Corrigendum - 2

Name of Work: Engineering, Procurement and Construction (EPC) of Judicial Officers Residential Flats and External Infrastructure Development Works at Sector-19 Dwarka, Delhi.

Tender No: WAP/C&C/DelhiLaw/2026/01 dated 30.07.2026

BASEMENT NON TOWER AREA
INDICATIVE STRUCTURE DRAWINGS

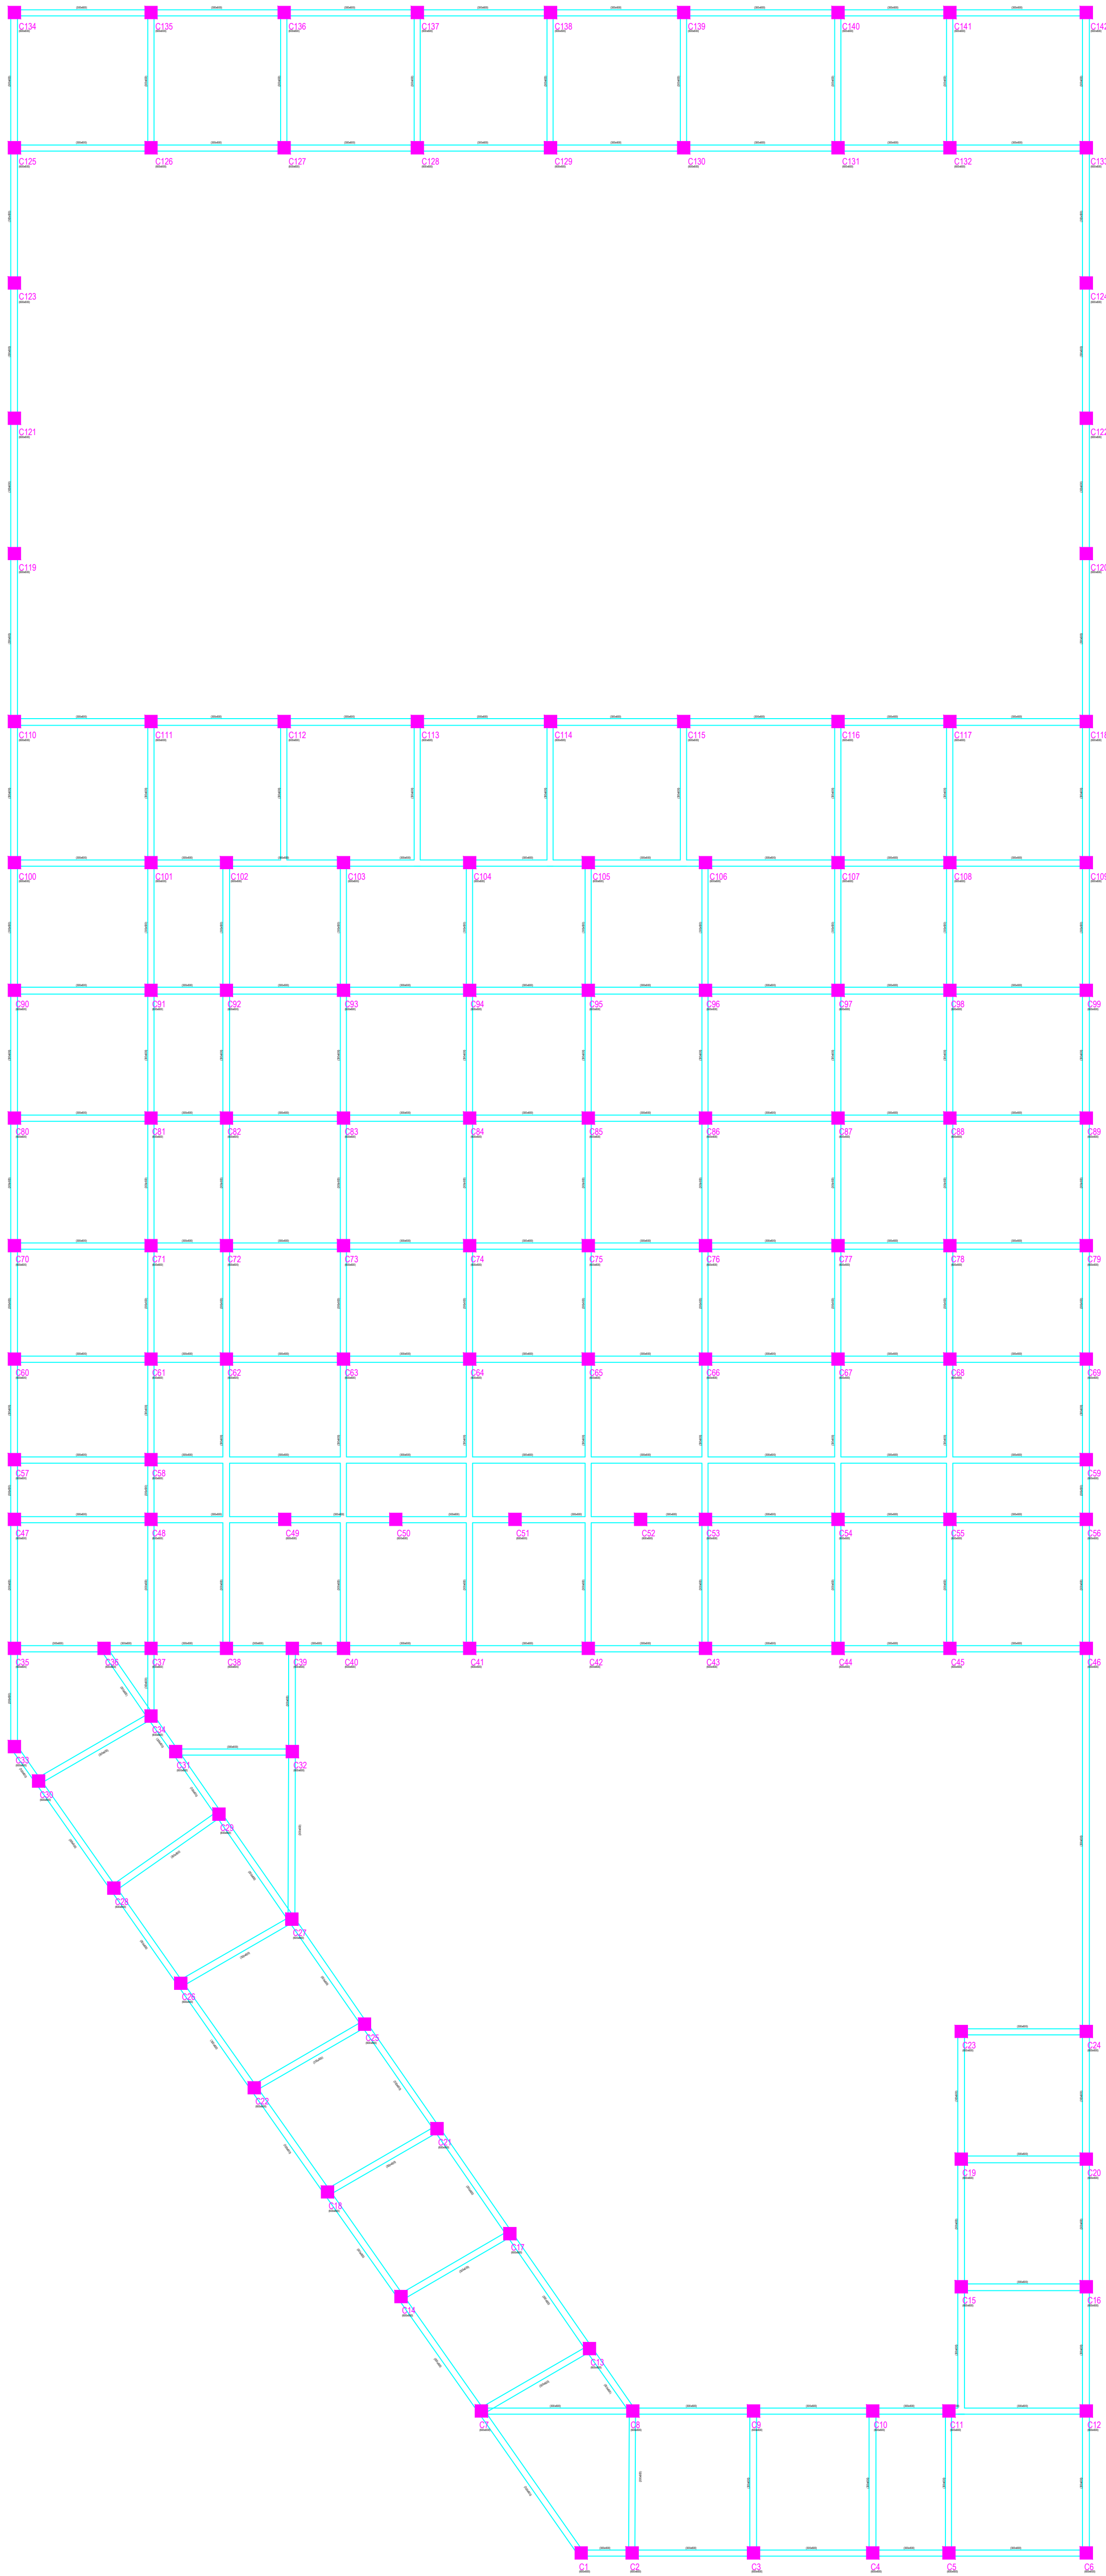
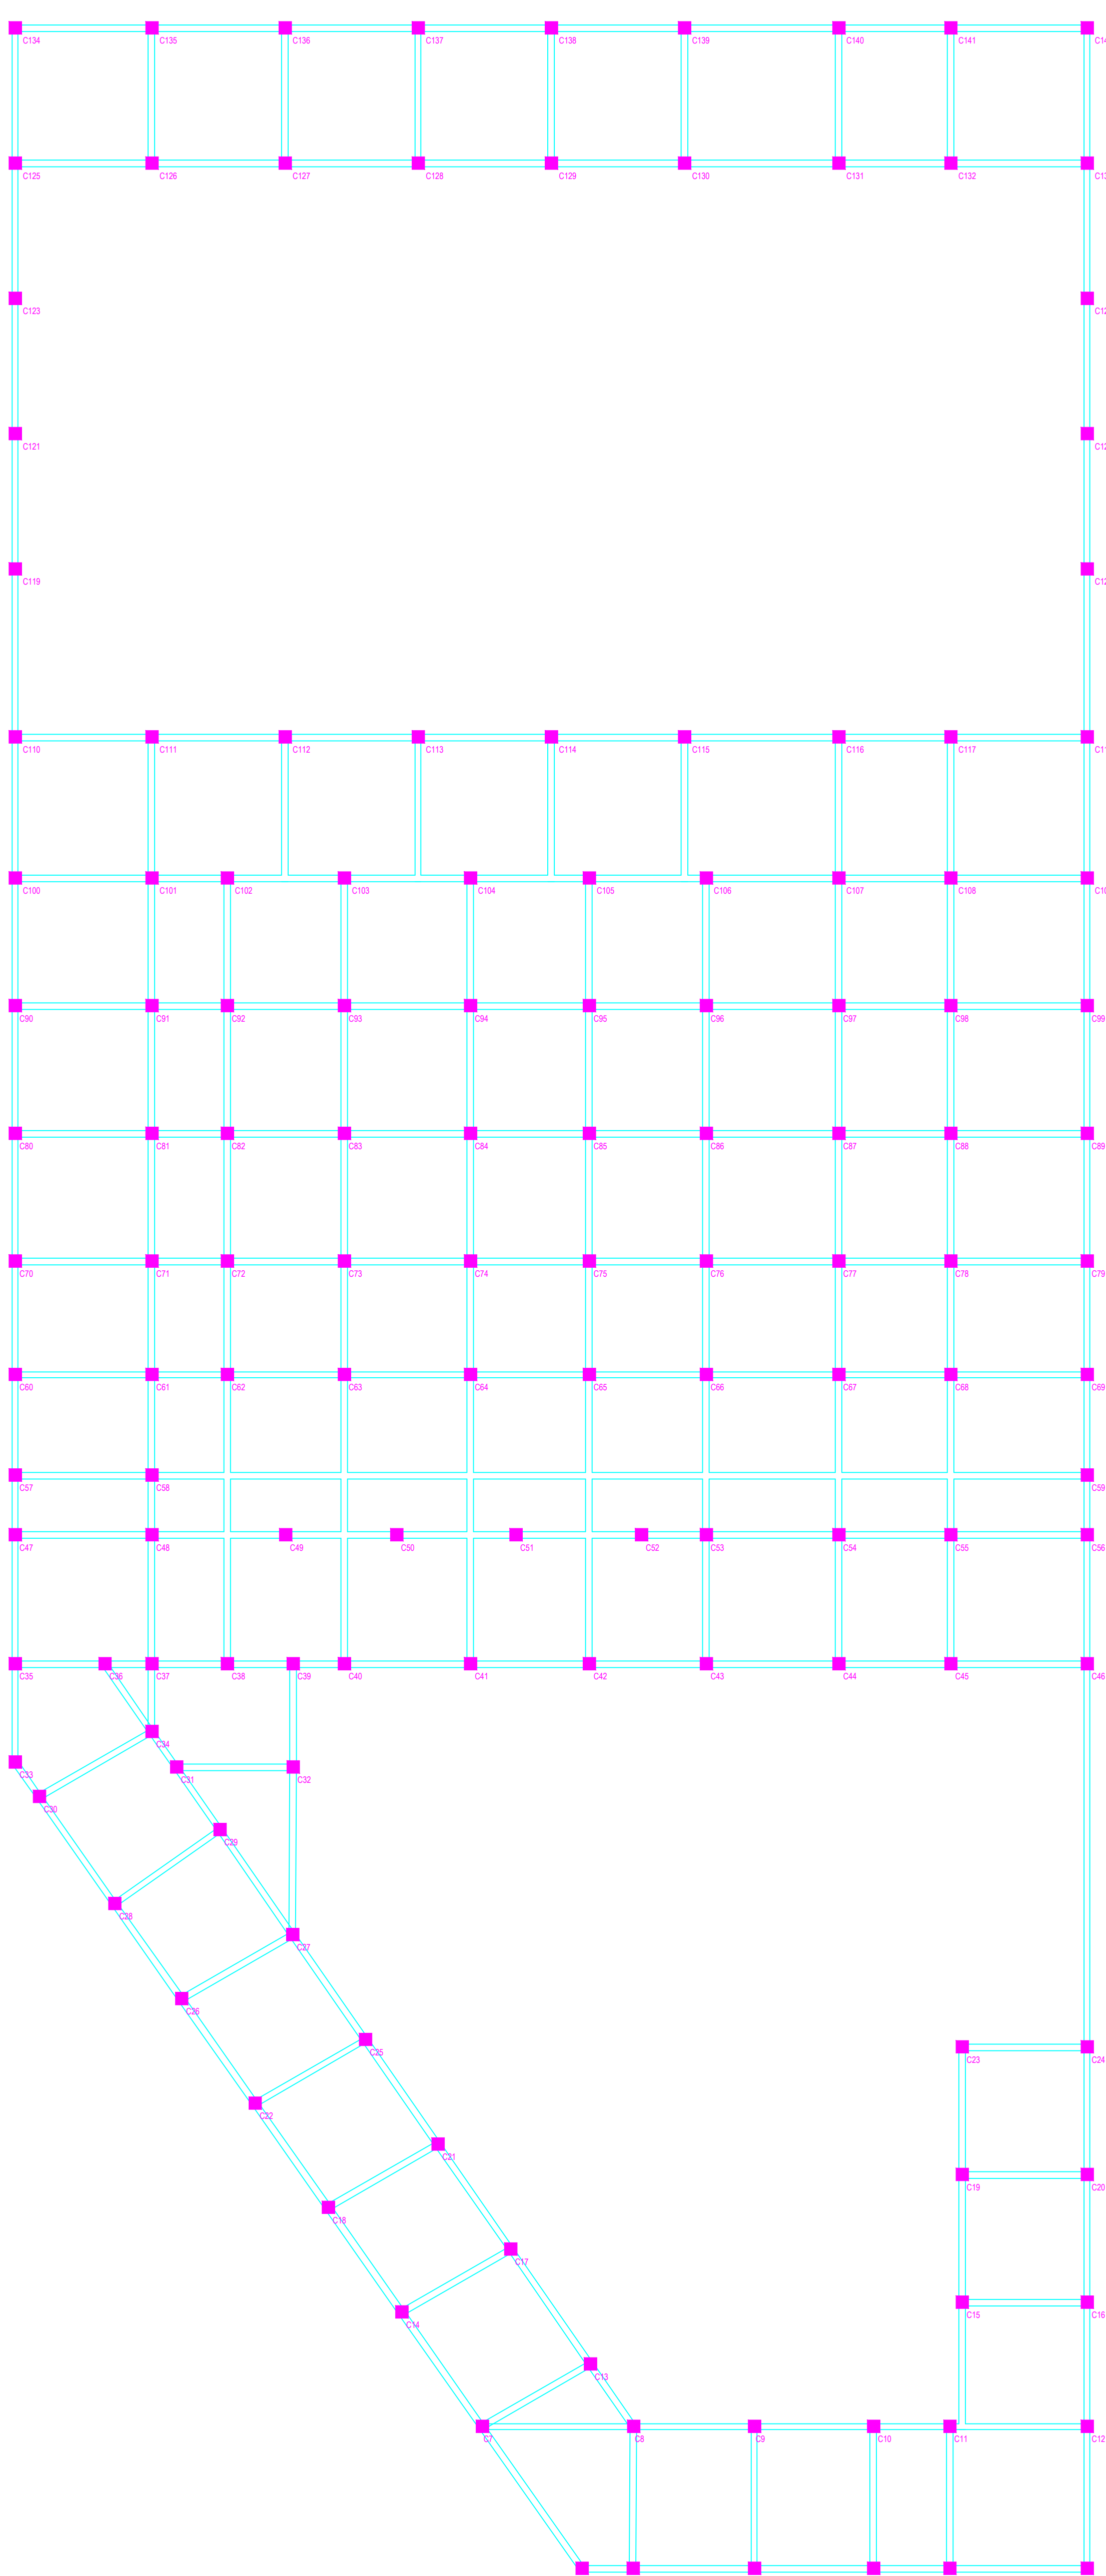
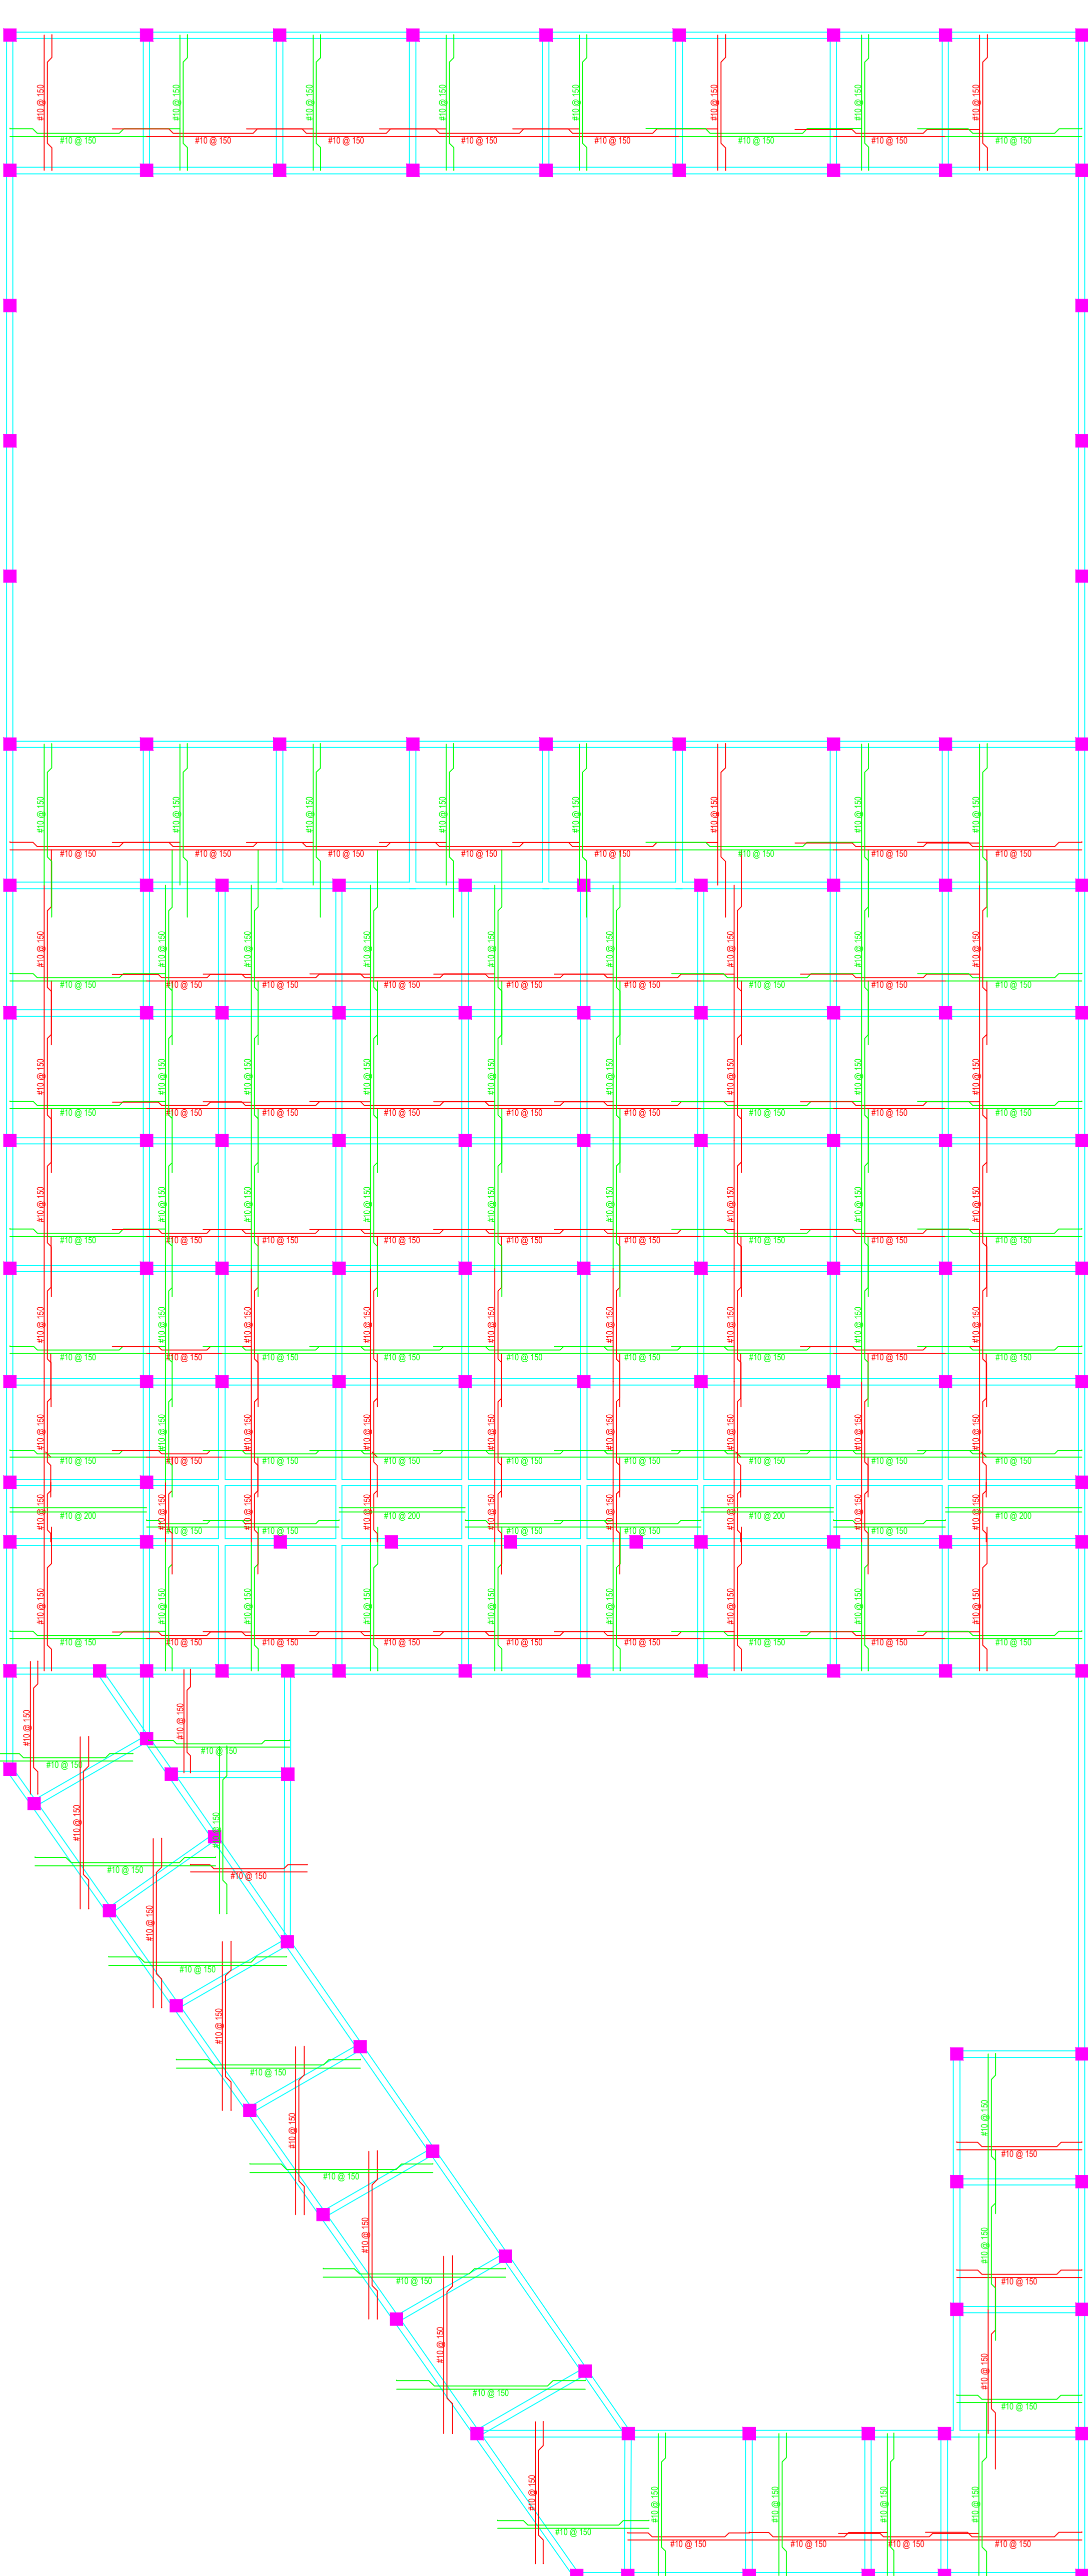
on the architectural layout mentioned list of drawing section of tender document. Bidder shall propose the structural system in line with performance and loading parameter mentioned in the structural DBR.		
8	Page 1074 of 1159	Basement	Non-tower basement area structural framing plan:-	We could not find the non-tower basement area structural framing plan. Only typical section of basement column is provided at Pg. No.1074 of 1159, however, column reinforcement schedule is not found. Further, no details (sizes & reinforcement details) of beam & slab are provided. In view of the same, detailed quantity working is not possible from available drawings & details. Thus, kindly provide these details for correct quantity working of the same.	Indicative Drawings Attached as Annexure-I.
9	Pg. 121	Revision In Design of Construction Technology:-	Regarding any other construction methodology / technology, it is mentioned at Pg. 121 that "Detailed Structural Drawings - Already included in this bid document. The contractor needs to verify the structural design. If the contractor wishes to revise the design and I or technology of construction, he needs to submit the proposal to WAPCOS for approval. In that case the contractor needs to prepare and get the structural	In this regard, kindly clarify whether price adjustment shall be made for any variation in quantities of materials required for work as compared to the quantities as per original tender drawings. We presume that price adjustment is applicable only in case of variation in plinth area in proportion of cost quoted for the subject, no adjustment shall be made for any quantity or method variation.	As per Tender Document.

additional eligibility criteria.			
4	Page 66	Clause IA, Security Deposit		It may be clarified that as per Point a and b, half of Retention money will be released on taking over certificate and balance within 60 days of completion of DLP. Also as per Page 65, Clause 1, Performance Security Point (ii) says Performance Bank Guarantee will be valid up to stipulated date of completion plus one year claim period beyond date of completion, including DLP and this will be released within one year of completion of DLP. This seems contradictory and may be clarified. Normally Security Deposit is released on completion of work, here PBG and Security Deposit both are being withheld till after completion of DLP.	As per Tender Document.
5				Number of structural as well as Architectural drawings, forming part of the contract, have been found enclosed with the tender documents. We request to also provide structural details of Basement foundation showing location and number of columns in Non-Tower portion as well because only structural drawings mostly for Tower portion have been found enclosed with the tender.	Indicative Drawings Attached as Annexure-I.
